STATE OF HAWAII
DEPARTMENT OF LAND AND NATURAL RESOURCES
COMMISSION ON WATER RESOURCE MANAGEMENT
P.O. BOX 621
HONOLULU, HAWAII 96809

STAFF SUBMITTAL

August 29, 2019
Wailuku, Hawaii

Approval of a Stream Diversion Works Permit Application (SDWP.4950.6)
by East Maui Irrigation Company to Remove and Abandon 11 Diversions (Category 3)
on the Honopou, Hanehoi (Puolua), and Pi'ina'au (Palauhulu) Streams,
East Maui Irrigation System, East Maui, Hawai'i; TMK: Various

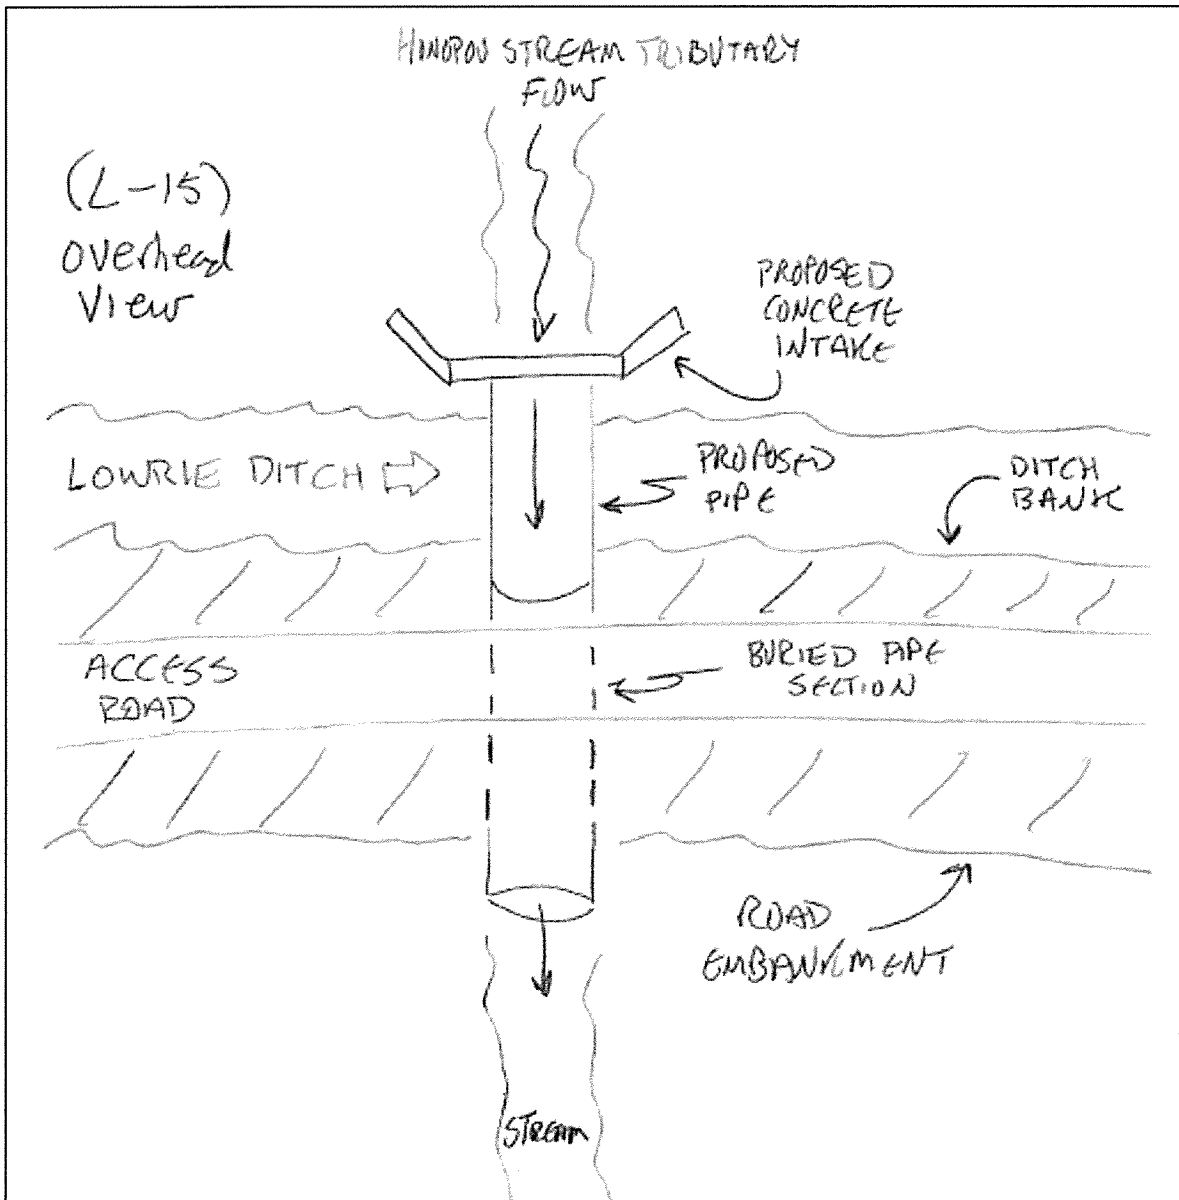
DAR Comments (Exhibit 4): The application seems to consistently use a stream overpass at various ditches without specifications or analysis of high flows. It appears that the Lowrie Ditch is being given priority over the Stream. EMI's proposed modifications maintains the Lowrie ditch and access road, not the natural stream. The typical stream overpass will allow most of the water during high flows to overflow into the ditch and only maintains a minimal flow from mauka to makai. The pipe transporting water downstream pours into the lower stream. If water is allowed to flow out of the pipe, migrating 'ōpae or 'o'opu cannot jump into the pipe. The proposed concrete pipe will not help upstream migration of native animals. DAR also has maintenance and inspection concerns.

FWS Comments (Exhibit 9): Native gobies move up stream corridors for reproduction. However, they will not pass through dark spaces (pipes). We recommend keeping diversions open as much as is feasible to accomplish the restoration of stream flow. Two listed animal species have the potential to either be in or fly through the vicinity of the project area - the Pacific Hawaiian damselfly (*Megalagrion pacificum*) and the Hawaiian hoary bat (*Lasiurus cinereus semotus*). Both are threatened by predation and habitat loss. We recommend not to disturb, remove, or trim woody plants greater than 15 feet tall during the birthing and pup-rearing season (June 1 – Sept 15).

Commission Staff Recommendations: The Commission staff, in order to more quickly effectuate the conveyance of water downstream, supports the construction of a stream overpass over the Lowrie Ditch as proposed by EMI. Due to the small size of the tributary upstream of Lowrie Ditch, it is anticipated that the tributary will not provide sufficient habitat for stream biota. Additionally, EMI intends to bury the pipe under the existing road makai and adjacent to the Lowrie Ditch in order to maintain use of the road. Use of an open channel bypass, as alluded to by DAR and DOFAW, would require cementing the road to create a ford crossing and could result in downstream erosion of the road over time. The Commission staff does recommend that the pipe size should be no smaller than 24-inches to prevent clogging and potential maintenance issues.

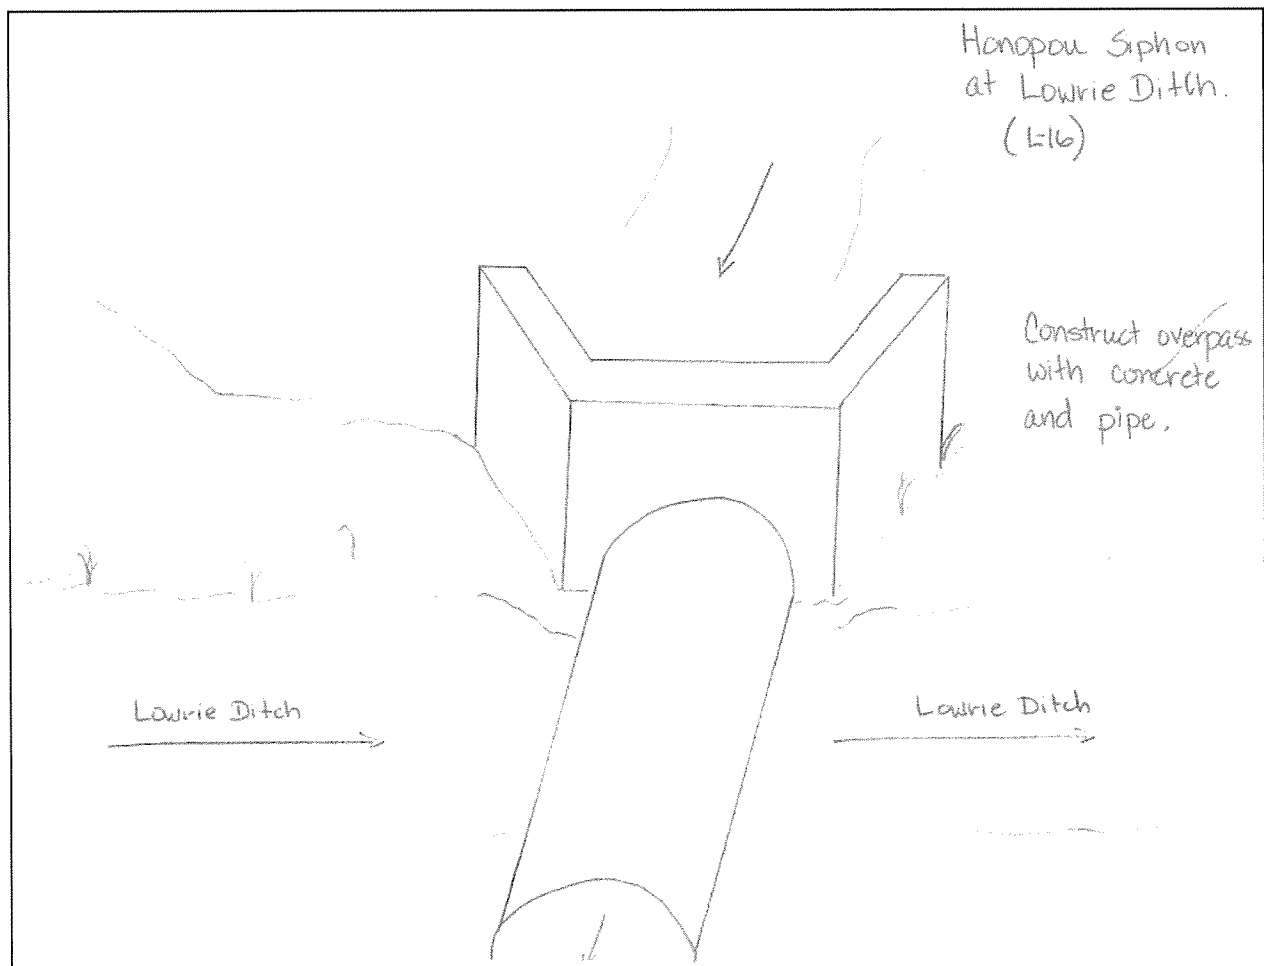
DAR Comments: The application seems to consistently use a stream overpass at various ditches without specifications or analysis of high flows. It appears that the Lowrie Ditch is being given priority over the Stream. EMI's proposed modifications maintains the Lowrie ditch and access

FWS Comments: Native gobies move up stream corridors for reproduction. However, they will not pass through dark spaces (pipes). We recommend keeping diversions open as much as is feasible to accomplish the restoration of stream flow. Two listed animal species have the potential to either be in or fly through the vicinity of the project area - the Pacific Hawaiian damselfly (*Megalagrion pacificum*) and the Hawaiian hoary bat (*Lasiurus cinereus semotus*). Both are threatened by predation and habitat loss. We recommend not to disturb, remove, or

trim woody plants greater than 15 feet tall during the birthing and pup-rearing season (June 1 – Sept 15).

Commission Staff Recommendations: The Commission staff, in order to more quickly effectuate the conveyance of water downstream, supports the construction of a stream overpass over the Lowrie Ditch. EMI, in its submitted SDWP application, had not finalized plans for a stream overpass and was considering an open concrete structure. While the small size of the tributary upstream of Lowrie Ditch is not anticipated to provide sufficient habitat for stream biota, the Commission staff recommends the construction of an open concrete channel, as considered initially, with a minimum width of 24-inches (See **Photo 3** below for example).

Photo 4. EMI proposed actions at Honopou at Haiku Ditch (H-8).

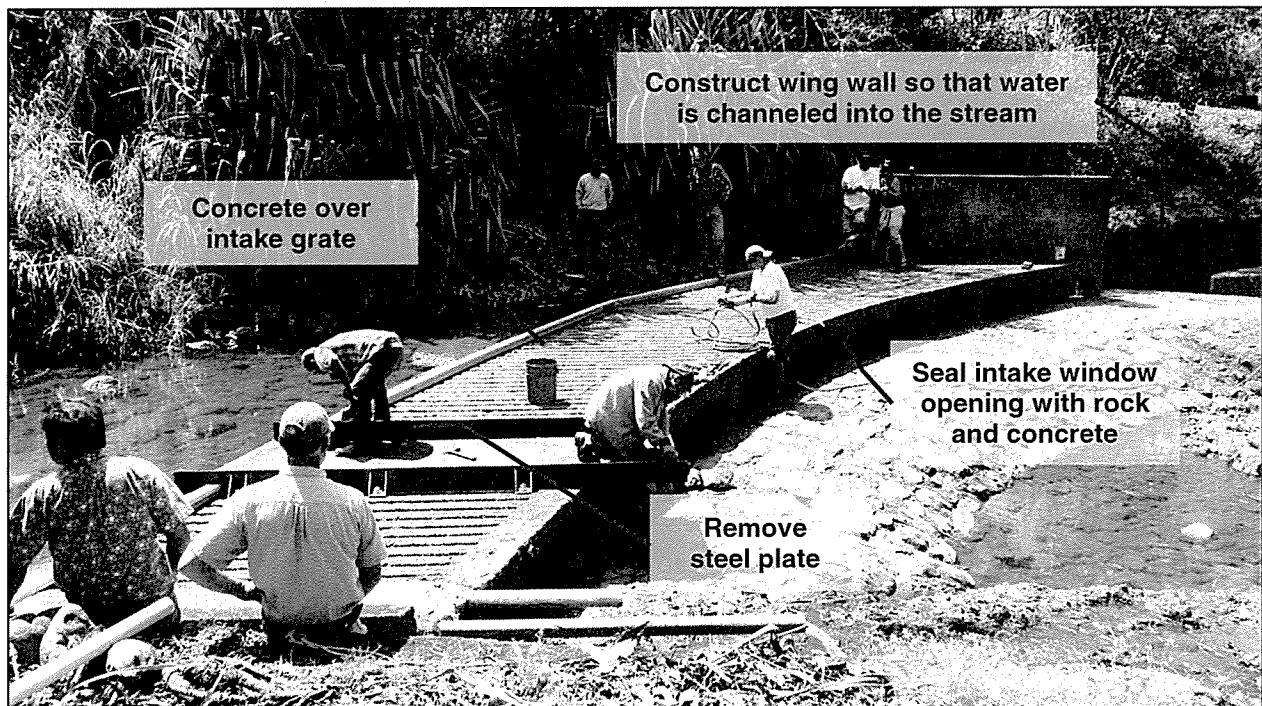
DAR Comments: Will the barrier be removed which increases the height of the water to flow over the metal section? It might be better to lower the elevation on the Hana side of the pool and allow a continuous flow over the concrete portion by the pipes. Please remove all of the pipes and lower that side of the diversion.

DOFAW Comments: In addition to measures identified in the application, please remove the steel plate that overhangs the stream as it may obstruct fish passage.

Commission Staff Recommendations: The Commission staff supports the modifications as proposed by EMI with the additional recommendations to: 1) Remove the low-flow steel plate and associated L-brackets, and concrete lip on the upstream edge of the intake grate; 2) Remove pipes on the east side of the intake grates; and 3) Construct an angled downstream face when sealing the intake window to promote fish passage across the structure.

3. Honopou at Haiku Ditch (H-8): Seal diversion at Haiku Ditch as proposed by EMI ,with the additional recommendations by Commission staff to: 1) Remove the low-flow steel plate and associated L-brackets, and concrete lip on the upstream edge of the intake grate; 2) Remove pipes on the east side of the intake grates; and 3) Construct an angled downstream face when sealing the intake window to promote fish passage across the structure.

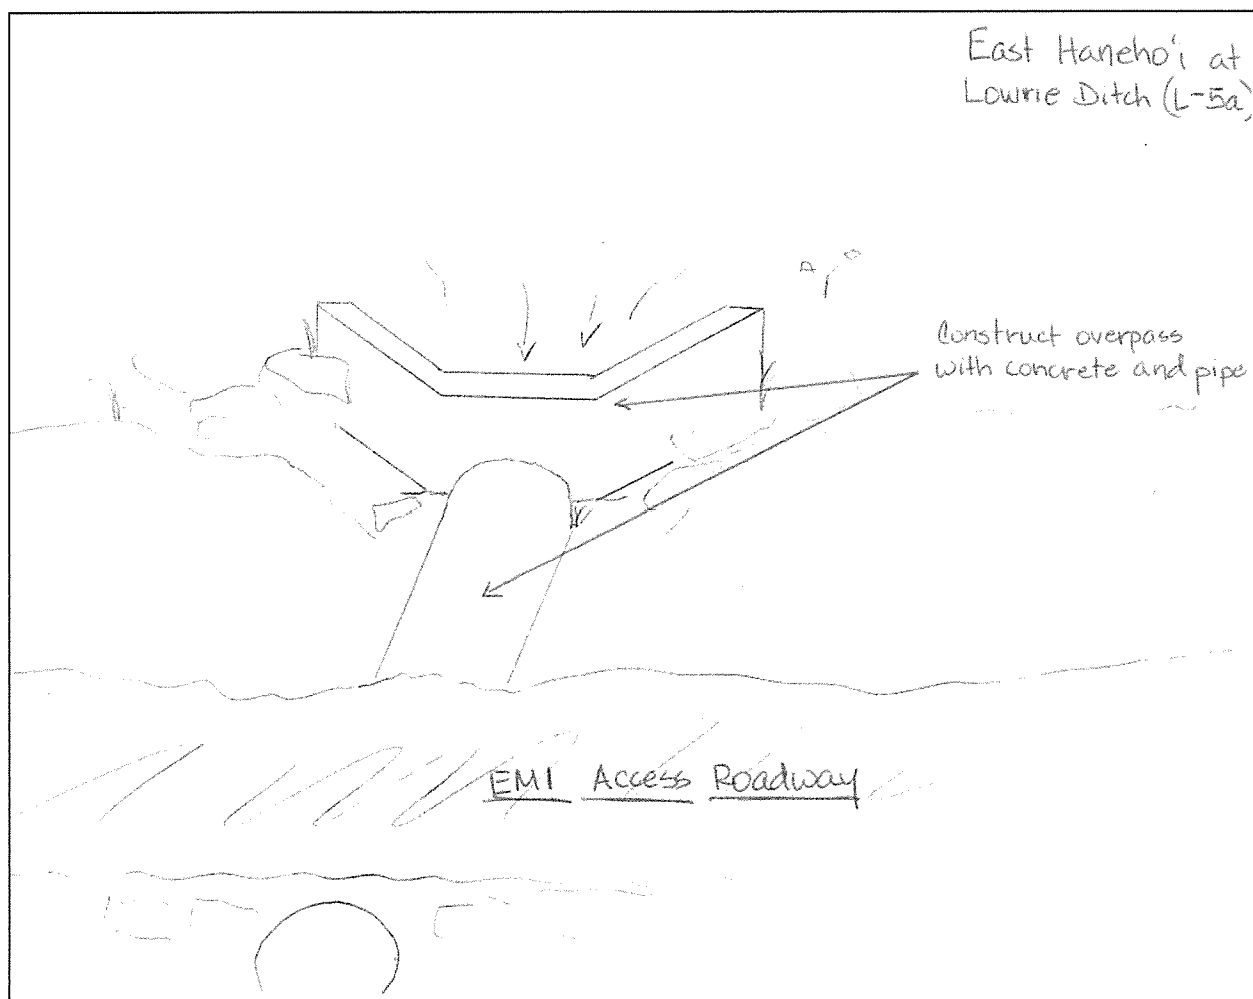
DAR Comments: The application seems to consistently use a stream overpass at various ditches without specifications or analysis of high flows. It appears that the Lowrie Ditch is being given priority over the Stream. EMI's proposed modifications maintains the Lowrie ditch and access

FWS Comments: Native gobies move up stream corridors for reproduction. However, they will not pass through dark spaces (pipes). We recommend keeping diversions open as much as is feasible to accomplish the restoration of stream flow. Two listed animal species have the potential to either be in or fly through the vicinity of the project area - the Pacific Hawaiian damselfly (*Megalagrion pacificum*) and the Hawaiian hoary bat (*Lasiurus cinereus semotus*). Both are threatened by predation and habitat loss. We recommend not to disturb, remove, or trim woody plants greater than 15 feet tall during the birthing and pup-rearing season (June 1 – Sept 15).

Commission Staff Recommendations: The Commission staff, in order to more quickly effectuate the conveyance of water downstream, supports the construction of a stream overpass over the Lowrie Ditch as proposed by EMI. Due to the small size of the tributary upstream of Lowrie Ditch, it is anticipated that the tributary will not provide sufficient habitat for stream biota. Additionally, EMI intends to bury the pipe under the existing road makai and adjacent to the Lowrie Ditch in order to maintain use of the road. Use of an open channel bypass, as alluded to by DAR and DOFAW, would require cementing the road to create a ford crossing and could result in downstream erosion of the road over time. The Commission staff does recommend that the pipe size should be no smaller than 24-inches to prevent clogging and potential maintenance issues.

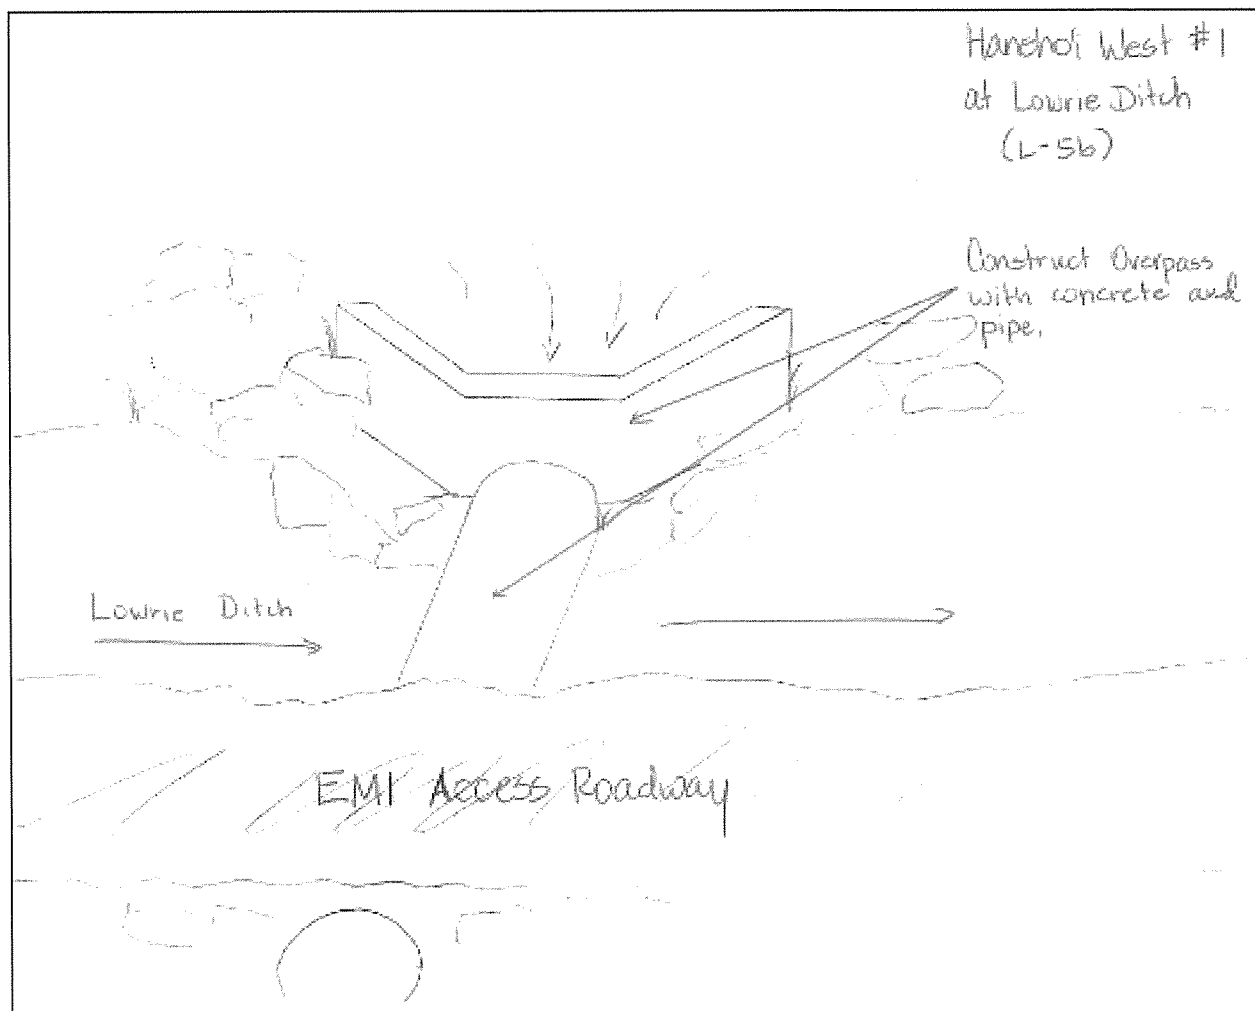
DAR Comments: The application seems to consistently use a stream overpass at various ditches without specifications or analysis of high flows. It appears that the Lowrie Ditch is being given priority over the Stream. EMI's proposed modifications maintains the Lowrie ditch and access road, not the natural stream. The typical stream overpass will allow most of the water during high flows to overflow into the ditch and only maintains a minimal flow from mauka to makai. The pipe transporting water downstream pours into the lower stream. If water is allowed to flow out of the pipe, migrating 'ōpae or 'o'opu cannot jump into the pipe. The proposed concrete pipe will not help upstream migration of native animals. DAR also has maintenance and inspection concerns. Could a box culvert be used to encase the ditch? It would be appropriate to allow the stream to flow naturally over the ditch. This appears to be a larger stream which likely has a higher flow during heavy storms.

FWS Comments: Native gobies move up stream corridors for reproduction. However, they will not pass through dark spaces (pipes). We recommend keeping diversions open as much as is feasible to accomplish the restoration of stream flow. Two listed animal species have the potential to either be in or fly through the vicinity of the project area - the Pacific Hawaiian damselfly (*Megalagrion pacificum*) and the Hawaiian hoary bat (*Lasiurus cinereus semotus*). Both are threatened by predation and habitat loss. We recommend not to disturb, remove, or trim woody plants greater than 15 feet tall during the birthing and pup-rearing season (June 1 – Sept 15).

Commission Staff Recommendations: The Commission staff, in order to more quickly effectuate the conveyance of water downstream, supports the construction of a stream overpass over the Lowrie Ditch as proposed by EMI. Due to the small size of the tributary upstream of Lowrie Ditch, it is anticipated that the tributary will not provide sufficient habitat for stream biota. Additionally, EMI intends to bury the pipe under the existing road makai and adjacent to the Lowrie Ditch in order to maintain use of the road. Use of an open channel bypass, as alluded to by DAR and DOFAW, would require cementing the road to create a ford crossing and could result in downstream erosion of the road over time. The Commission staff does recommend that the pipe size should be no smaller than 24-inches to prevent clogging and potential maintenance issues.

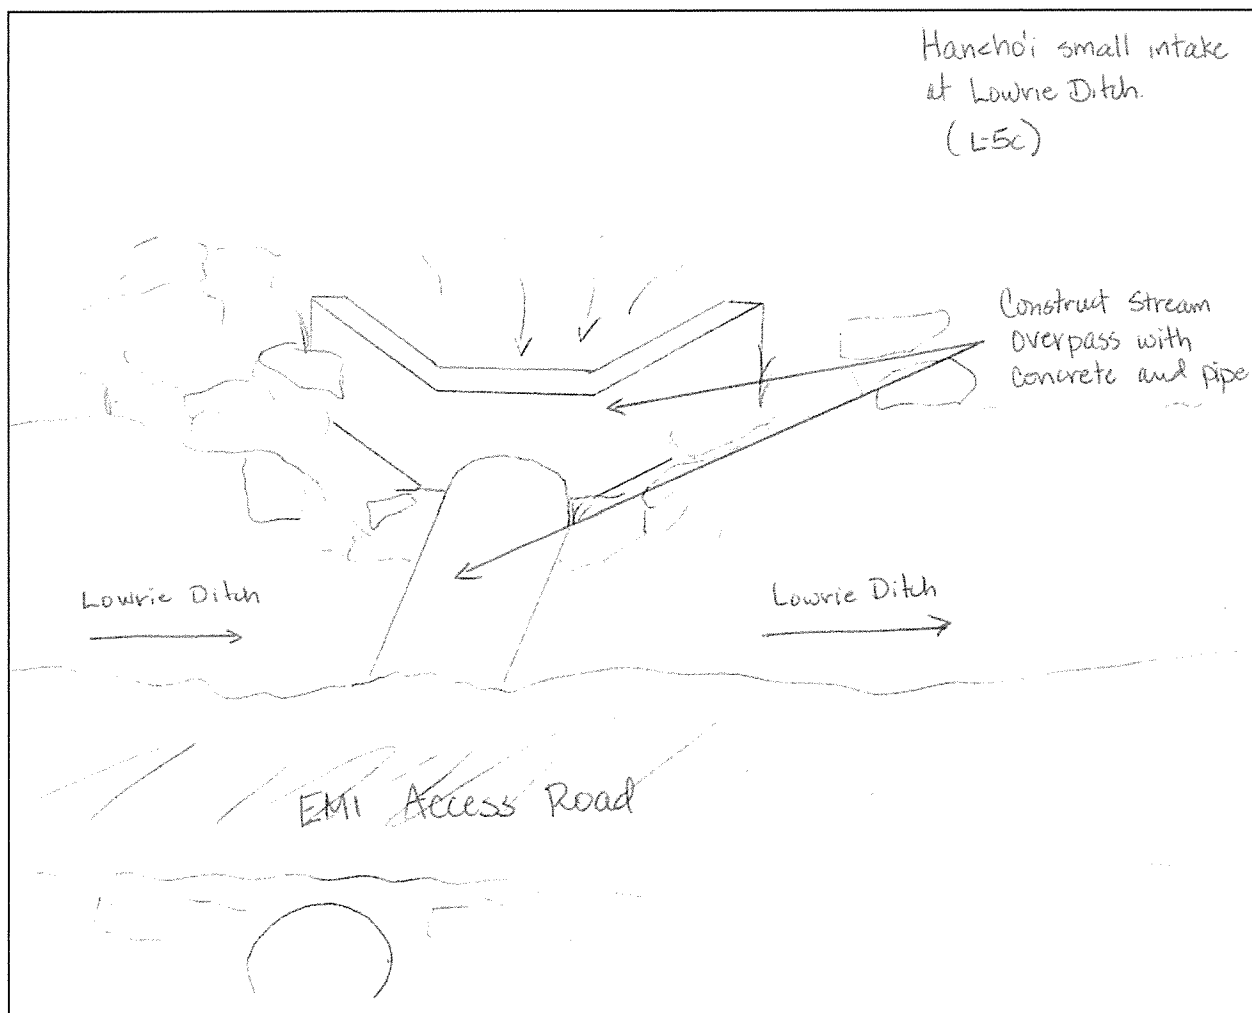
DAR Comments: The application seems to consistently use a stream overpass at various ditches without specifications or analysis of high flows. It appears that the Lowrie Ditch is being given

priority over the Stream. EMI's proposed modifications maintains the Lowrie ditch and access road, not the natural stream. The typical stream overpass will allow most of the water during high flows to overflow into the ditch and only maintains a minimal flow from mauka to makai. The pipe transporting water downstream pours into the lower stream. If water is allowed to flow out of the pipe, migrating 'ōpae or 'o'opu cannot jump into the pipe. The proposed concrete pipe will not help upstream migration of native animals. DAR also has maintenance and inspection concerns. Need more information.

FWS Comments: Native gobies move up stream corridors for reproduction. However, they will not pass through dark spaces (pipes). We recommend keeping diversions open as much as is feasible to accomplish the restoration of stream flow. Two listed animal species have the potential to either be in or fly through the vicinity of the project area - the Pacific Hawaiian damselfly (*Megalagrion pacificum*) and the Hawaiian hoary bat (*Lasiurus cinereus semotus*). Both are threatened by predation and habitat loss. We recommend not to disturb, remove, or trim woody plants greater than 15 feet tall during the birthing and pup-rearing season (June 1 – Sept 15).

Commission Staff Recommendations: The Commission staff, in order to more quickly effectuate the conveyance of water downstream, supports the construction of a stream overpass over the Lowrie Ditch as proposed by EMI. Due to the small size of the tributary upstream of Lowrie Ditch, it is anticipated that the tributary will not provide sufficient habitat for stream biota. Additionally, EMI intends to bury the pipe under the existing road makai and adjacent to the Lowrie Ditch in order to maintain use of the road. Use of an open channel bypass, as alluded to by DAR and DOFAW, would require cementing the road to create a ford crossing and could result in downstream erosion of the road over time. The Commission staff does recommend that the pipe size should be no smaller than 24-inches to prevent clogging and potential maintenance issues.
